Access Compliance Report

Public Rights-of-Way

Intersection ID: 12073	Main Street: E_11TH_ST	Cross Street: N_CALDWELL_ST	Location: W
ADA ID: B3932A8A0D79	Ramp Type: PerpDiag	Initial Pass/Fail: Fail	Overall Compliance: No
		Severity Score: 10

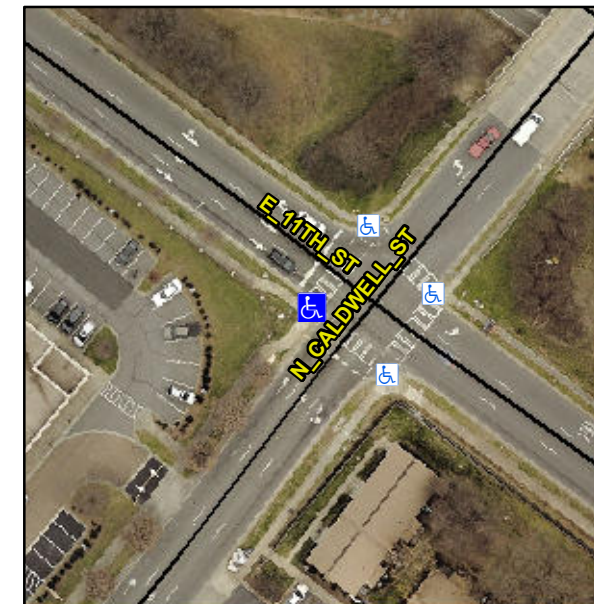
Not Found, R304.5.1, R304.5.3

Compliance	Description	Data	Compliance	Description	Data
N/A	Ramp Length (in)	57.0	Yes	Ramp Slope (%)	7.9
No	Ramp Width (in)	41.0	No	Ramp XSlope (%)	3.3
N/A	Flare Type LT	N/A	N/A	Flare Type RT	N/A
N/A	Flare Slope LT (%)	N/A	N/A	Flare Slope RT (%)	N/A
N/A	Flare Traversable LT?	N/A	N/A	Flare Traversable RT?	N/A
N/A	Landing Length (in)	N/A	N/A	DWS Provided?	N/A
N/A	Landing Width (in)	N/A	N/A	DWS Contrast?	N/A
N/A	Landing Slope (%)	N/A	N/A	DWS Length (in)	N/A
N/A	Landing X Slope (%)	N/A	N/A	DWS Full Width?	N/A
N/A	Landing Curb? (Y/N)	N/A	N/A	DWS Offset (in)	N/A
N/A	Shared Landing?	N/A			
N/A	Gutter Ponding?	N/A	N/A	Gutter Slope (%)	N/A
N/A	Gutter Lip Ht (in)	1.5	N/A	Gutter X Slope (%)	N/A
N/A	Painted X Walk1?	Yes	N/A	Painted X Walk2?	Yes
	X Walk 1 Direction	To SE		X Walk 2 Direction	To NE
N/A	X Walk 1 Width (in)	108.0	N/A	X Walk 2 Width (in)	112.0
	X Walk 1 Slope (%)	1.1		X Walk 2 Slope (%)	2.0
	X Walk 1 X Slope (%)	5.4		X Walk 2 X Slope (%)	3.2

Remove & Replace Curb Ramp With Two New Directional Ramps or Equivalent.
